March 11, 2026

**Re: Proposed General Plan and Zoning Code Amendments Relating to Capitola Mall**

James Gwilliam  
Managing Director  
Merlone Geier Partners

**Signing & Marking**  
Shared Lane Markings

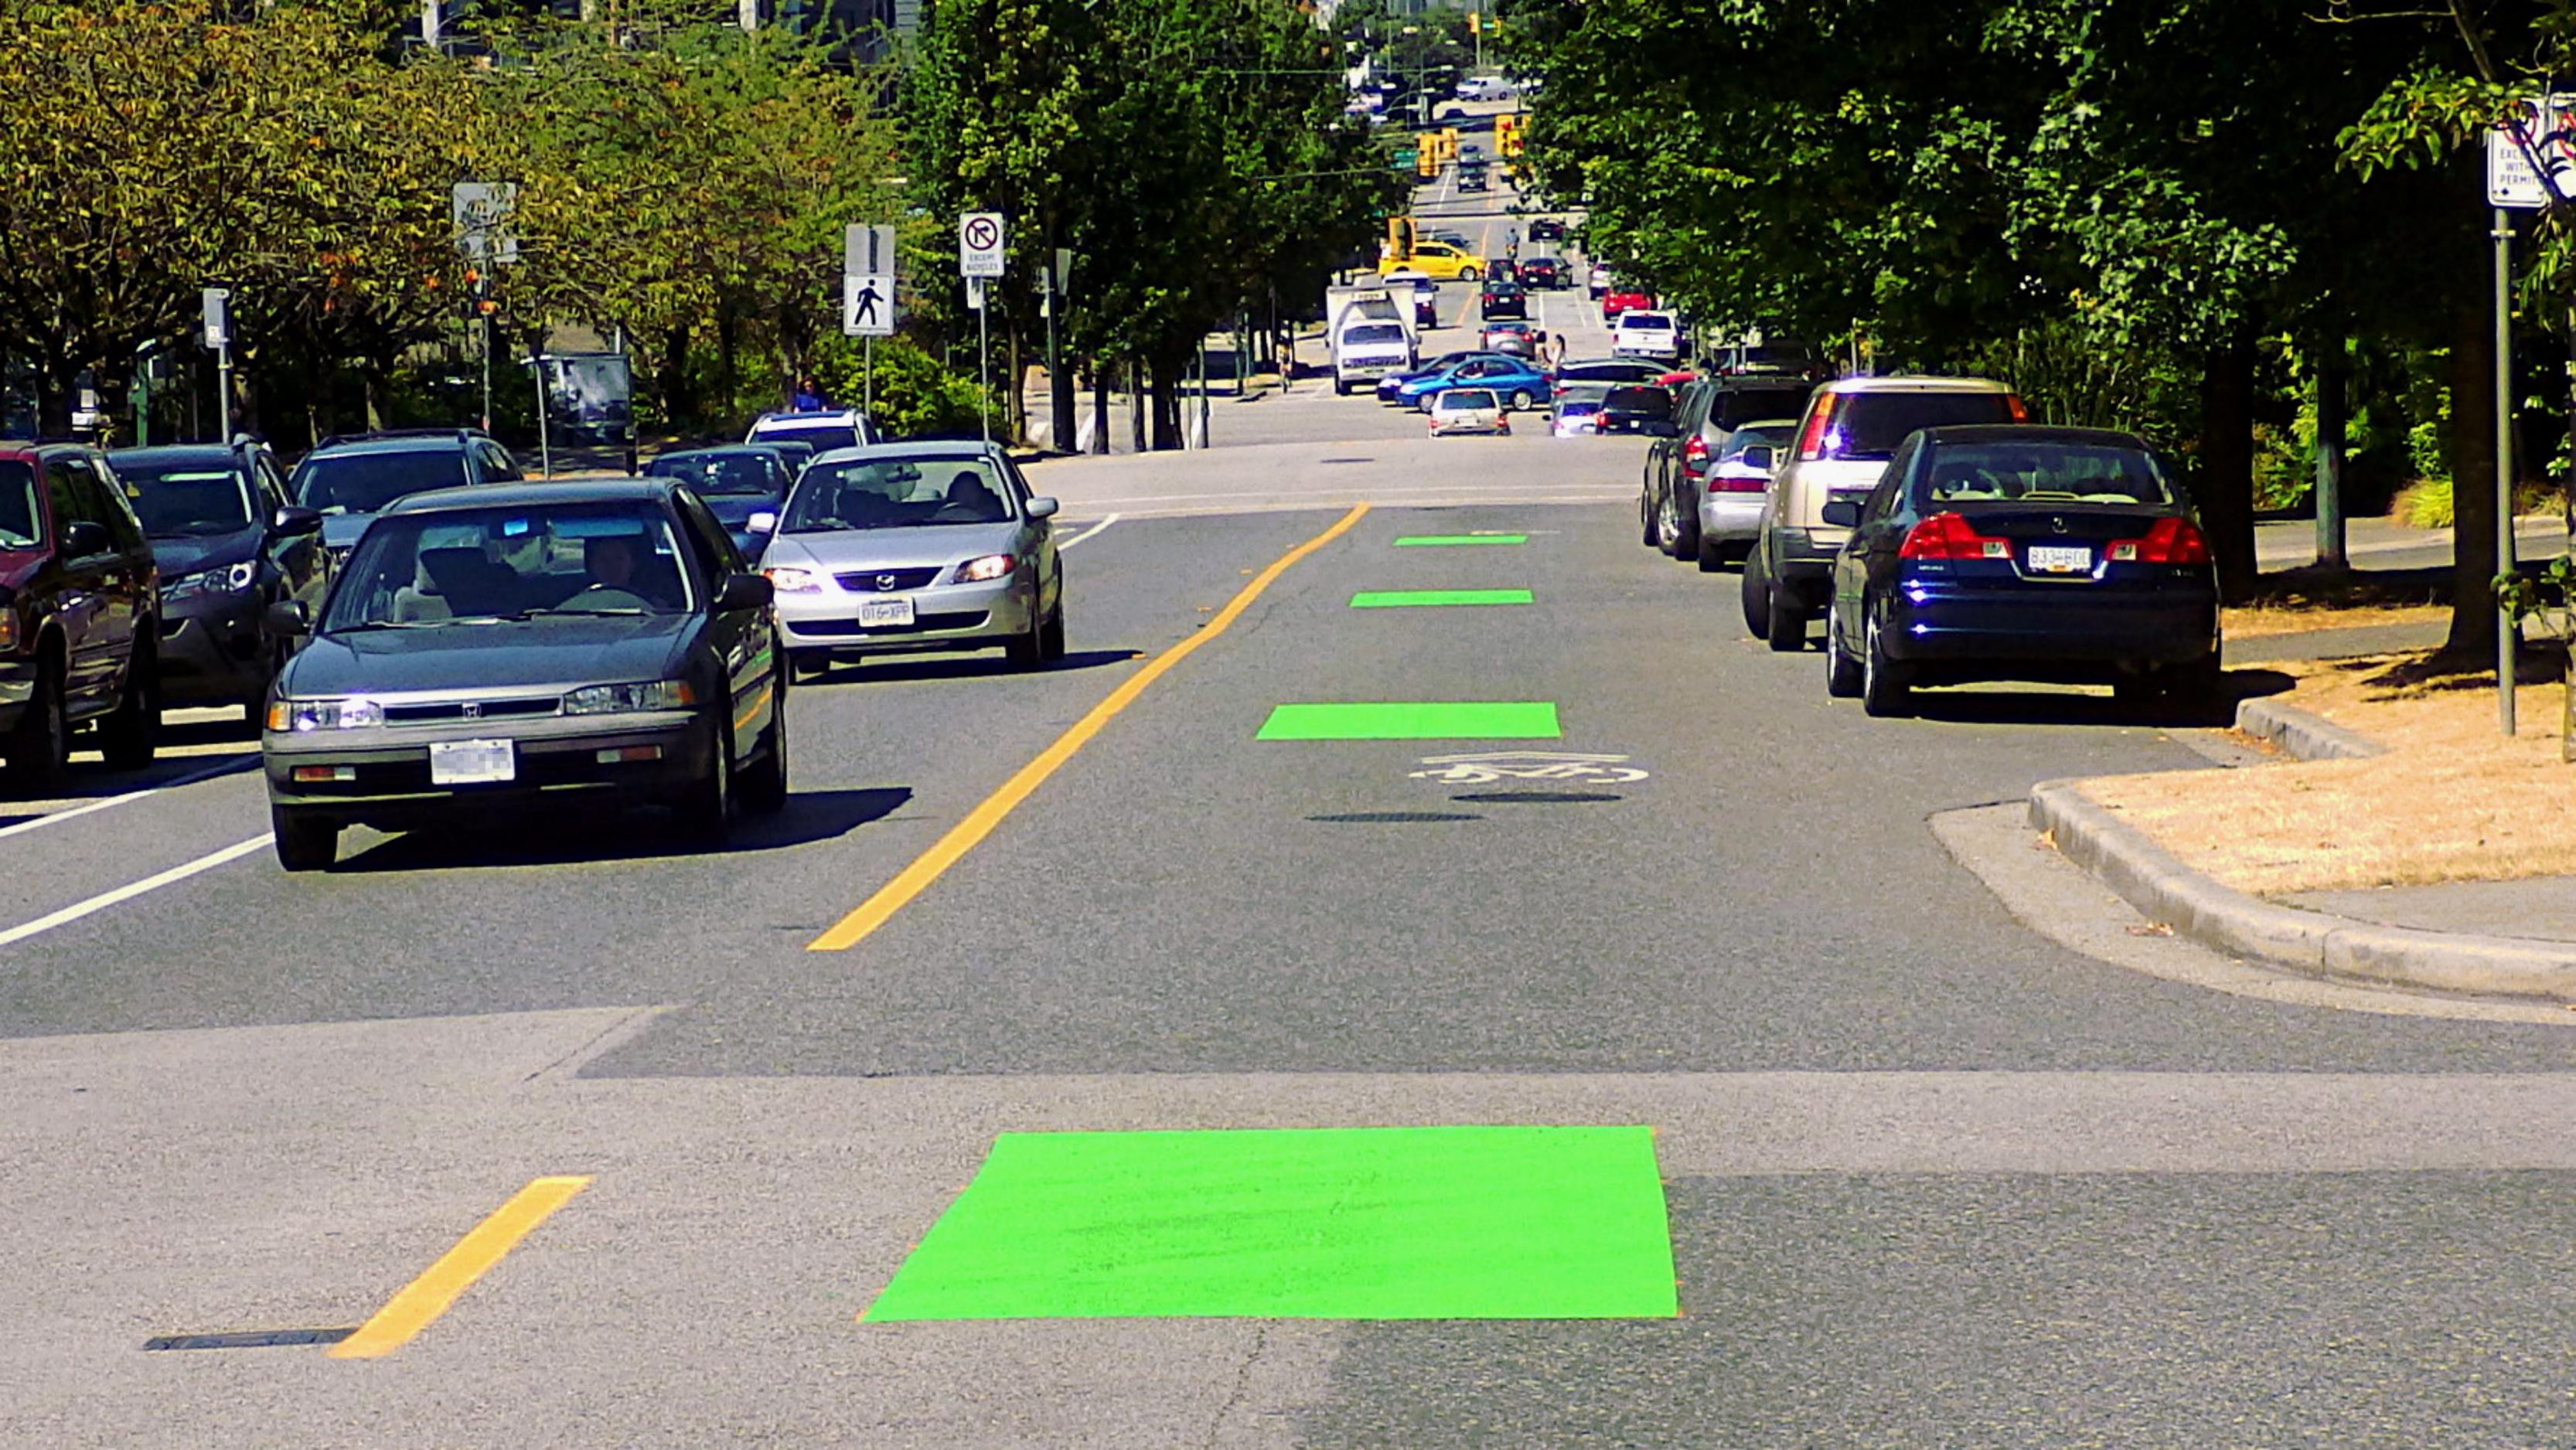
At our Village at San Antonio project, sharrows were successfully implemented on private streets with both parallel and angled parking. However, sharrows were not used on streets that connected directly to or traversed through parking lots, as those conditions present too many potential conflict points between vehicles and cyclists.

We also recommend revising Section 17.57.050.A.2.f to allow sharrow lanes on private streets regardless of whether they abut ground-floor commercial uses.
